## Hornsby Shire Council

Hornsby Quarry Rehabilitation works including bulk earthworks (and associated civil works including construction of access tracks, drainage and retaining walls), site remediation, tree removal, revegetation work and site rehabilitation

Response to Submissions and Revised Project Scope

**Hornsby Quarry Rehabilitation EIS  
Response to Request for Additional information - Development Application No.  
DA/101/2019**

**Figure 02**

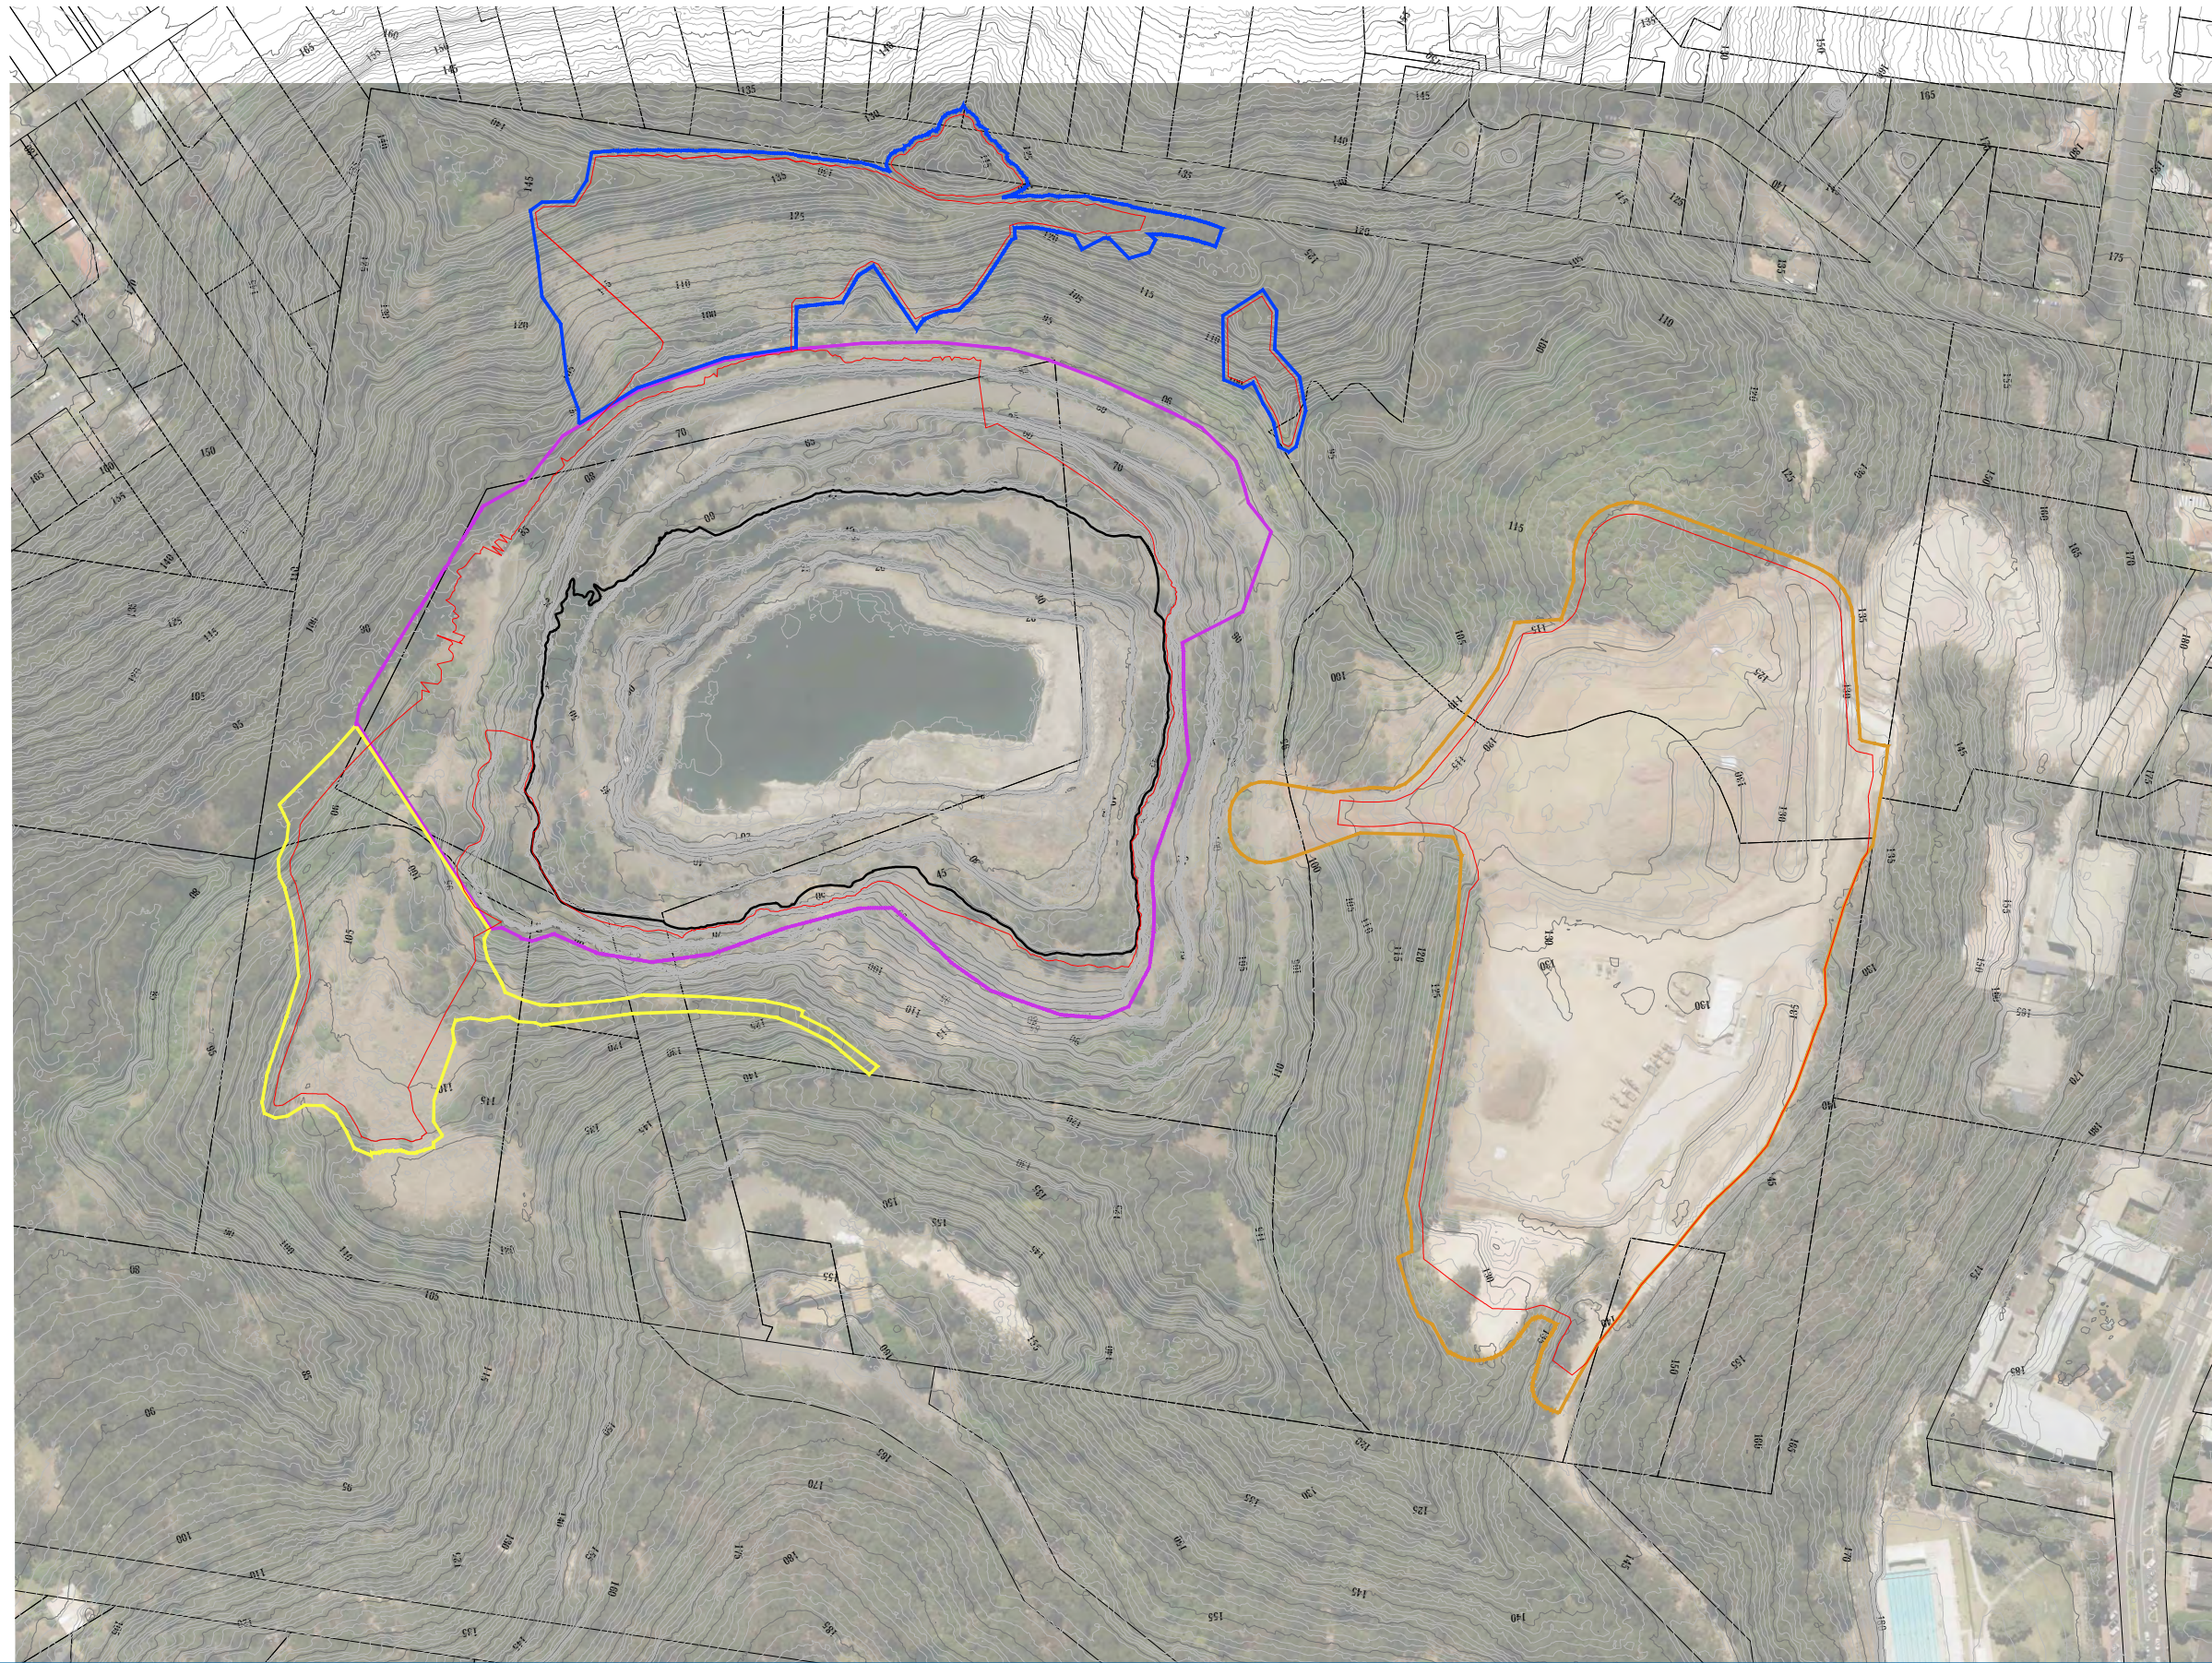
Figure 03 - Cross Section - Confirm that the 'existing surface level' is the surface level prior to filling in accordance with the 2016 Planning Approval	Figure 03 'existing surface level' is the surface level prior to filling in accordance with the 2016 Planning Approval. Refer revised Figure 03.
	Figure 04 - Extent of work - Overlay onto an aerial photograph with cadastre - Show locations of work zones - Delete vegetation communities	Refer revised Figure 04 provided showing aerial, cadastre and work zones, but without vegetation communities.
	Figure 05 - Site Management Plan - Show location of mobile crusher (unless this is equipment that will be moved around the site, as required, in which case indicative locations should be shown) and any other equipment that will be used on site for the duration of the works.	The mobile crusher, along with most equipment will be moved around the site as required. Potential construction scenarios are provided in the appendices of the Air Quality (Appendix D) and Noise (Appendix C) reports.

**Figure 06**

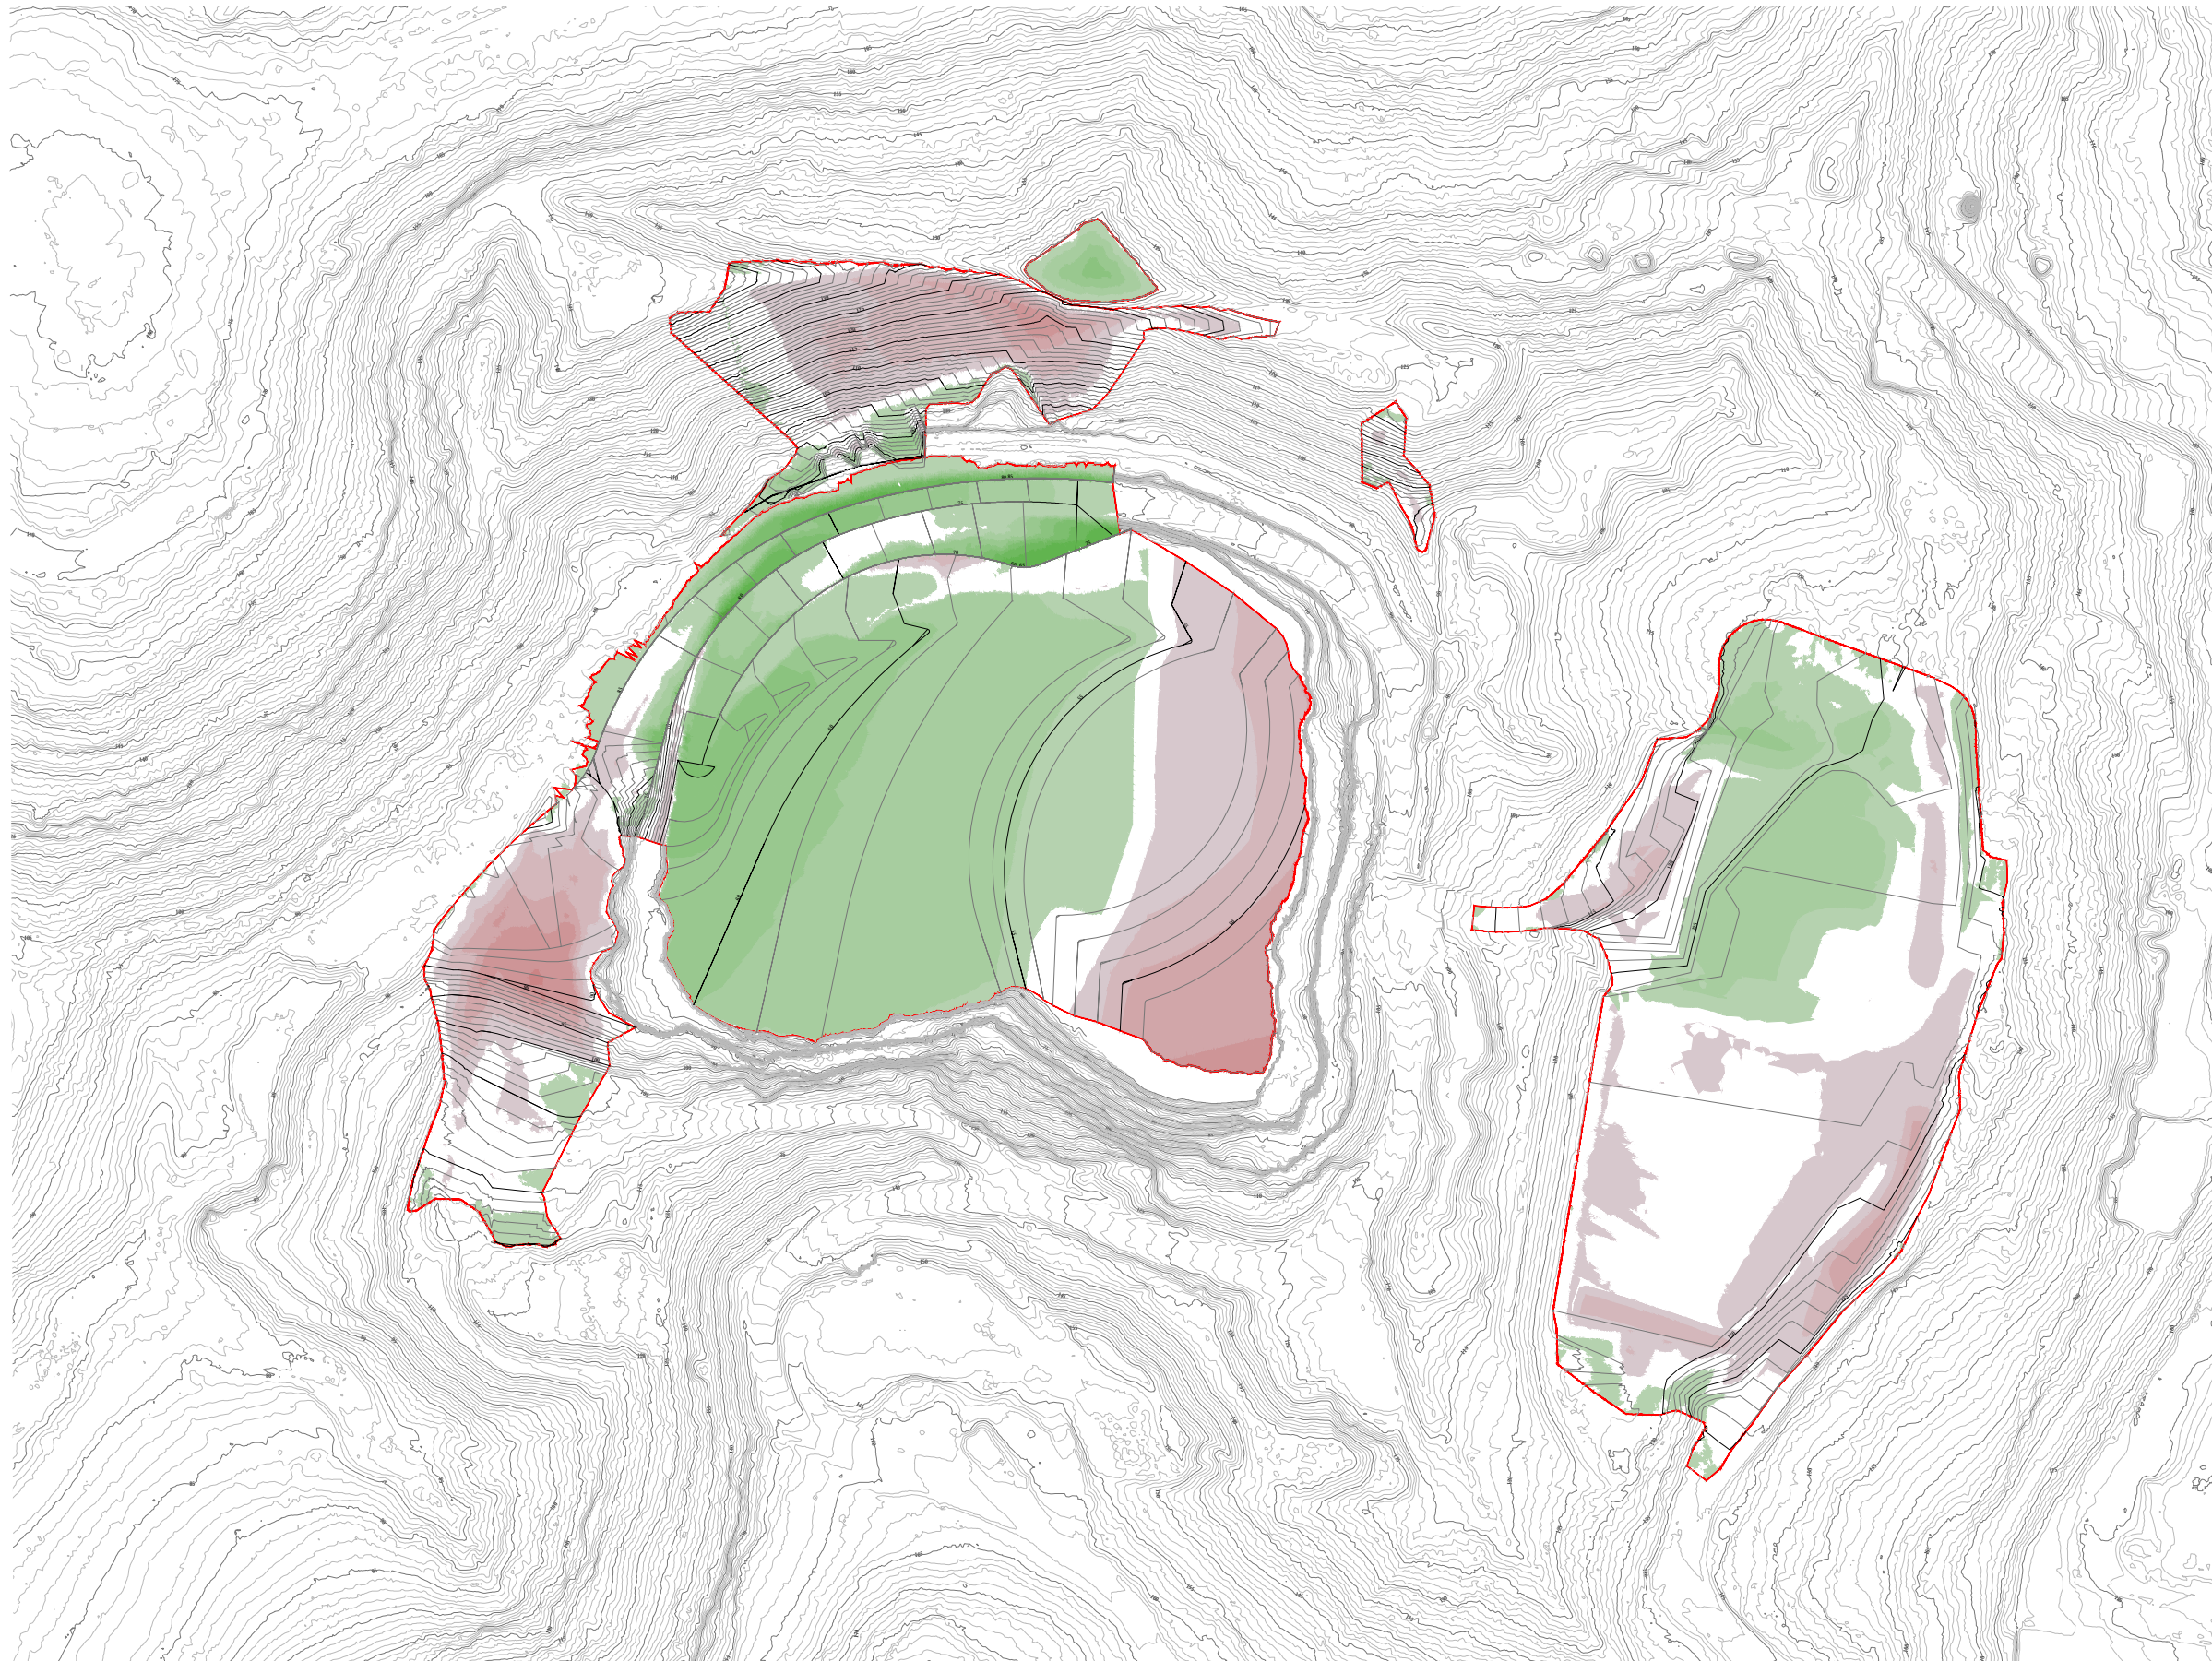
<b>Ref</b>	<b>Comment</b>	<b>Response</b>
	In relation to the bulk earthworks, details regarding the depths of excavation/filling (in more detail than Figure 6.2) would be of benefit.	Figure 6.2 of the EIS shows the proposed (concept design) surface after completion of the works as well as details of the estimated cut and fill depth in each area. No further detail is available at this current concept design stage.
<b>3.6.2</b>	<b>Construction</b>	
	Details of the methodology for undertaking the bulk earthworks to be specified as different methods will have different impacts	Chapter 6 of the EIS includes an indicative construction methodology and describes the type of plant required to undertake the works. This is based on the concept design and best understanding of the most likely construction methods at this stage.  The impacts of this particular method are assessed in the EIS, using estimated numbers of different plant items. The Air and Noise assessments analyse 3 different "worst case" type scenarios where the various plant items are working concurrently and in different parts of the site as it is expected that the plant items will be moved according to which areas of the site are being excavated or filled. The actual construction methods can only be confirmed once the detailed design has been completed and a construction contractor has been appointed.
